P&Z STAFF REPORT

Board of Appeals Meeting, December 8, 2021

Case: **V21-0033 – 4955 Riverview Road**
Staff Contact: Michele McIntosh-Ross (mmcintosh-ross@sandyspringsga.gov)
Report Date: November 29, 2021

Case: **V21-0032 & V21-0034 – 720 E. Northway Lane**
Staff Contact: Michele McIntosh-Ross (mmcintosh-ross@sandyspringsga.gov)
Report Date: November 29, 2021

SITE PLAN (received October 8, 2021) (full size Site Plan in Package)

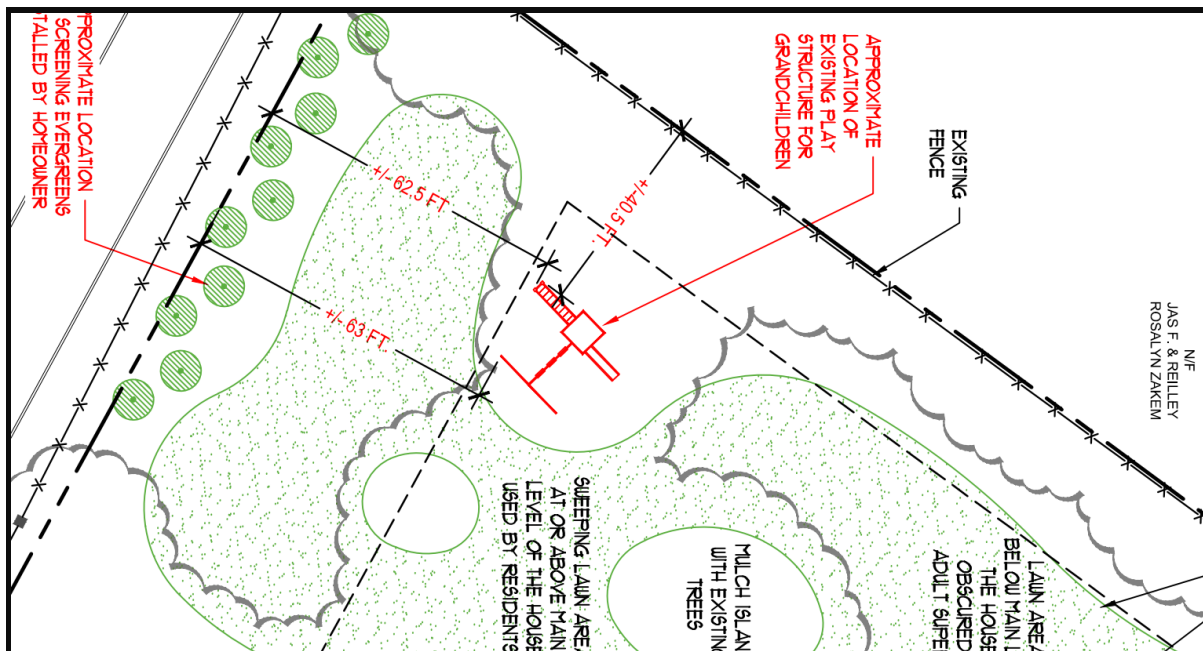
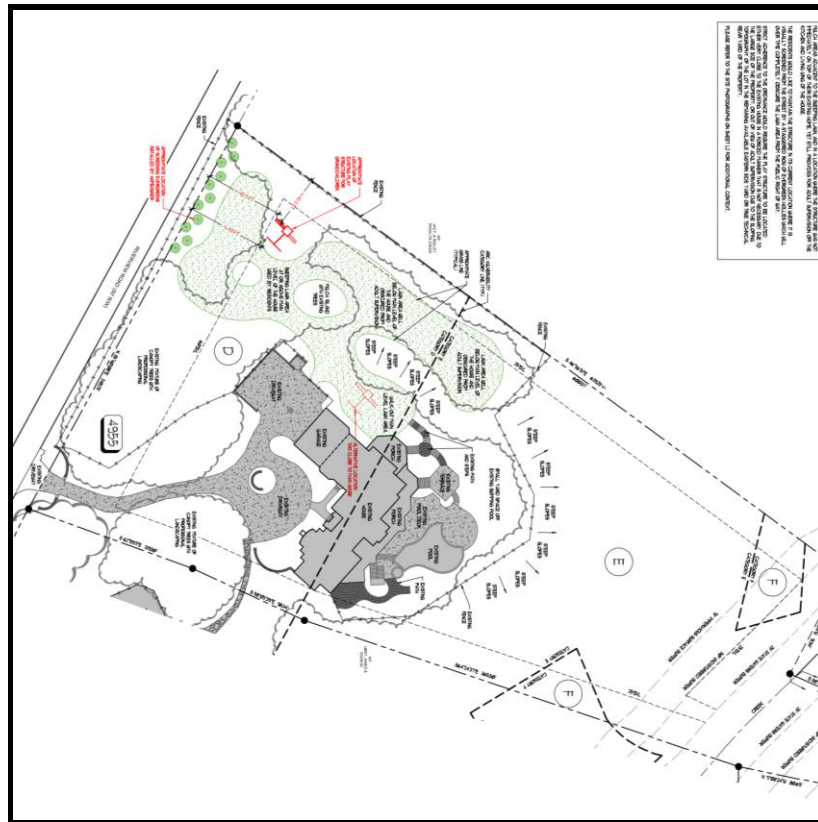
The Applicant requests a Variance from Sec. 7.8.22.A.2.a. to maintain the location of a play structure in the front yard, between the main building and the primary street.

Finding: The application of the Development Code would not create an unnecessary hardship.

Finding: The subject property is 3.80 acres in size, similar to others in the area, and the shape is almost rectangular with a wider street frontage and a narrower rear width. The grade on site is such that the highest elevation is at the street and changes approximately 100 feet along 515 linear feet to the stream at the low point at the back of the property. This property has been landscaped to create multiple flat and moderately sloping grassy areas around the house that would accommodate seating and leisure areas. There are no extraordinary and exceptional conditions due to the size, shape, or topography, which are specific to the subject property and not generally found in similar properties.

Finding: The Variance request would not provide the minimum relief necessary to make possible the reasonable use of the property. The subject property was and remains developed with a single unit estate residence, porches, decks, swimming pool, tennis court, driveway, and other features and improvements.

Finding: The Variance request would not result in development that is consistent with the general intent of the Development Code or *The Next Ten*. The Development Code requires that accessory structures, in this case a play structure for kids, may not be located between the primary street and front plain of the house. The request to maintain the location of a play structure in the front yard, between the main building and the primary street is inconsistent with the Code. A major feature of *The Next Ten* is to protect and preserve the City's neighborhoods, and a way in which that is codified is through building setback and other regulations governing the location of buildings and structures. Thus, the request would not result in development that is consistent with *The Next Ten*, either.

DEPARTMENT OF COMMUNITY DEVELOPMENT RECOMMENDATIONS
Following review, and based on the findings, Staff recommends Denial of Variance V21-0033, request for a Variance from Sec 7.8.22.A.1.a to maintain the location of a play structure in the front yard, between the main building and the primary street.

SITE PLAN (received October 25, 2021) (full size Plan in Package)

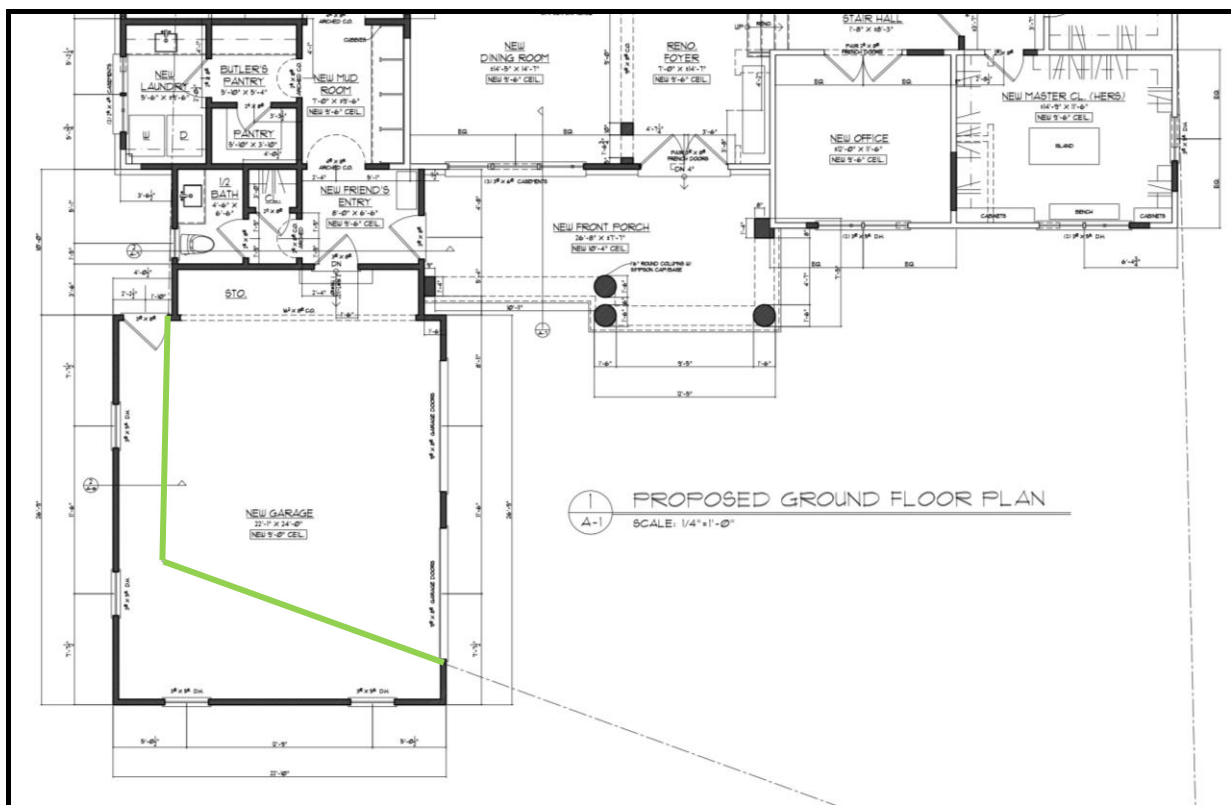
The footprint of the new garage addition is approximately 784 square feet. The addition will encroach into the side yard setback 3 feet, 7 inches, and into the front yard, primary street setback 12 feet, 9 inches. The applicant plans to reduce the lot coverage percentage from 34.6% to 32.4% by utilizing pervious pavers on the newly aligned driveway and remove the existing pool deck and replace with turf grass.

Tree removal is proposed including the removal of Landmark and Protected trees. This would cause the site to fall below the required minimum 35% canopy coverage for RD-18. Mitigation and recompense will be required.

Finding: The subject property is approximately 0.60 acre in size, similar to others in the area, and the shape is almost rectangular (rhombus). The grade rises approximately 14 feet from E. Northway Lane over approximately 85 linear feet to the front of the house. Behind the house, the yard undulates within a 6 foot range towards the rear of the property, with landscaped flat areas around the pool and pool house, and grassy areas. There are no extraordinary and exceptional conditions due to the size, shape, or topography, which are specific to the subject property and not generally found in similar properties.

Finding: The Variance request would not provide the minimum relief necessary to make possible the reasonable use of the property. The subject property, minus the home renovation to reconfigure and extend the garage, is reasonably developed with a single unit detached residence, including a driveway, front facing/ front entry garage, pool, pool house, patios, walls, and other features and improvements.

Finding: The Variance request would not result in development that is consistent with the general intent of the Development Code or *The Next Ten*. The Development Code requires that no garage may encroach into a required setback. The request to extend the garage into the side yard and front yard setbacks does not comply with the Code.

Following review, and based on the findings, Staff recommends **Denial** of **Variance V21-0032** and **Variance V21-0034** concurrently, from Sec. 2.3.2., Sec. 6.1.2.B, and Sec. 6.5.2.B.1. to construct a side-entry garage that will encroach 3 feet 7 inches into the northwestern side common lot line setback (V21-0032) and will encroach 12 feet 9 inches into the front yard, primary street setback (V21-0034).

1. To allow the construction of a new side-entry garage to the footprint shown on the Site Plan, Architectural Set prepared by Ross Piper Architect Inc., signed and sealed by Ross Piper, dated September 23, 2021.
 - i. That the measured encroachment into the side yard (3 feet 7 inches), and the measured encroachment into the primary street setback (12 feet 9 inches), do not exceed these listed herein; and
 - ii. That the lot coverage mitigation measures be implemented.
2. That a tree mitigation recompense plan approved by the City Arborist, is implemented.

VARIANCE SUMMARY (received October 25, 2021) (full size Site Plan in Package)

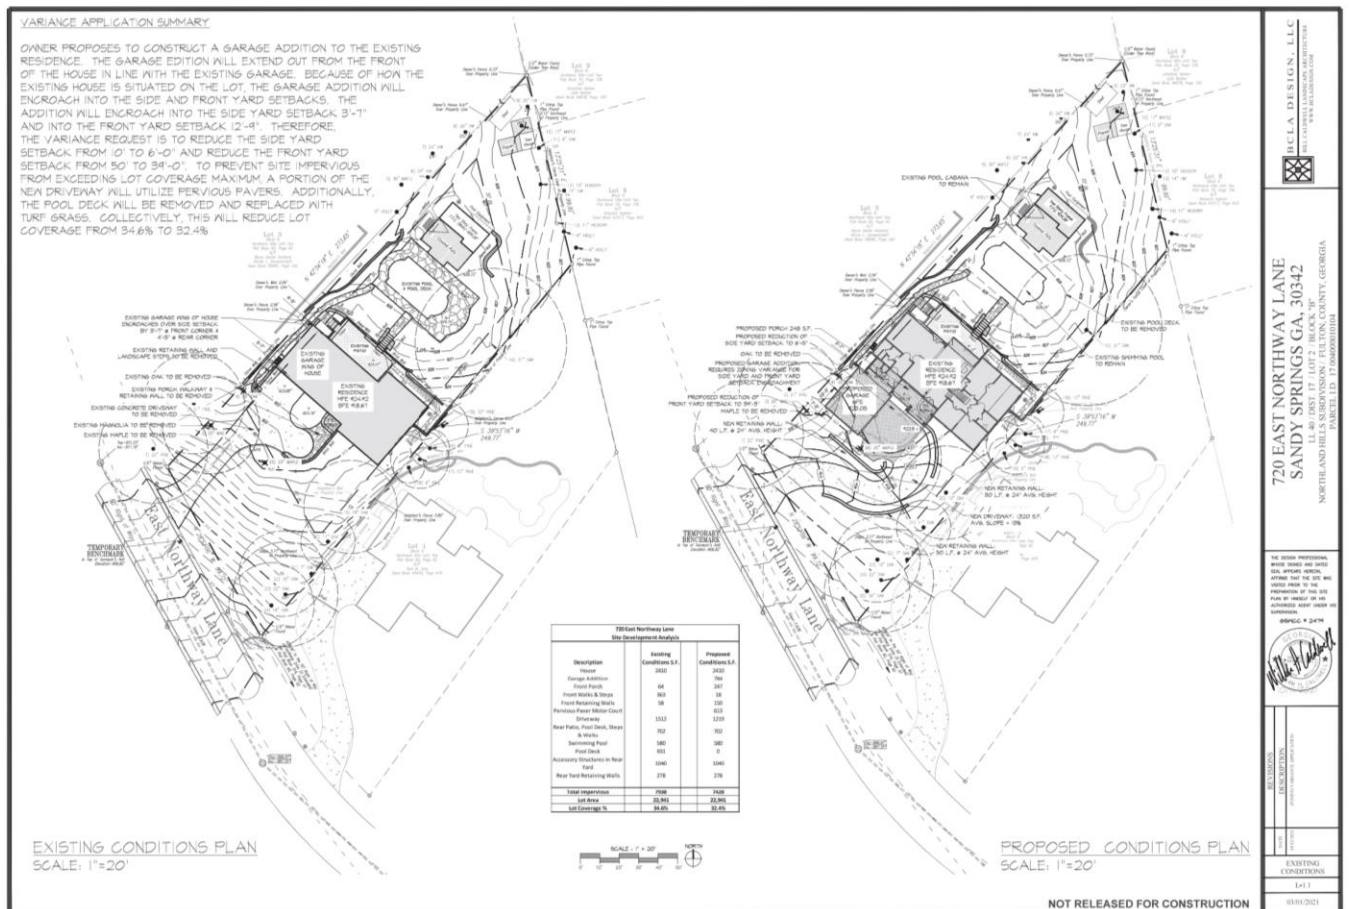
The applicant is requesting a variance from Section 2.3.2., Sec. 6.1.2.B, and Sec. 6.5.2.B.1. to construct a side-entry garage that will encroach into the northwest side common lot line setback (V21-0032).

The applicant is requesting a variance from Section 2.3.2., Sec. 6.1.2.B, and Sec. 6.5.2.B.1. to construct a side-entry garage that will encroach into the front yard, primary street setback (V21-0034).
